Application/Control Number: 10/561,728 Page 2

#### DETAILED ACTION

Figure A.

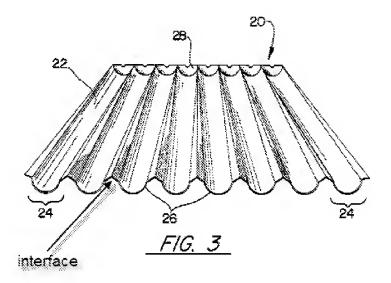
between adjacent channels that is heated as recited in claim 15 and that Buttner does nothing to cure this deficiency of Varvat. This is not persuasive. At the outset, according to line 9 of the abstract of Applicants' published application there is an interface (22, 24) between two channels and this interface is shown at 22 of Applicants' fig. 6a and described at paragraph [0121] of Applicants' published application. The interface 22 of Applicants' fig. 6a is heated by a flow of hot gas generated by the first heater as the hot gas flows around the channels. Similarly, Varvat shows an interface (figure 3 and figure A below) between two channels. A thorough examination of figures 1-3 of Varvat shows that a hot gas 48 (figure 1) flows along the outside of the channels between the channels and the baffles 32 (figure 1) as described at column 4, lines 48-62 to keep the hot gas flow separate from the noxious vapors released from the particulate being dried. The hot gas flows along the entire bottom portion of the channels including between the channels at the interface (figure 3 and figure A below). The hot gas must flow along the interface in order to get through the air passage created by the baffles 32a, 32b, 32c (figure 1, column 4, lines 21-28 describing the baffles defining a continuous air passage). Therefore, Varvat does disclose a first heater 42 (figure 1) for heating the channels 22 (figures 1-3) and the interface (figure 3 and figure A below) between adjacent channels.

Figure B.

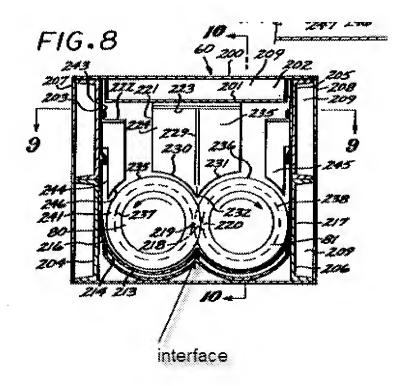
It would have been an obvious matter of design choice to increase the radius of the channels from 0.133 m (Buttner et al., column 35, lines 8-10 describing the screws as having a diameter of 10.5 inches or 0.267 meters and where the channels 213 conform to the diameter of the screws as shown in figure 8 and column 15, lines 6-20 describing optimizing the dryer for different dimensions) to 0.25 m, since such a modification would have involved a mere change in the size of a component. A change in size is generally recognized as being within the level of ordinary skill in the art. *In re Rose, 105 USPQ 237 (CCPA 1955)*.
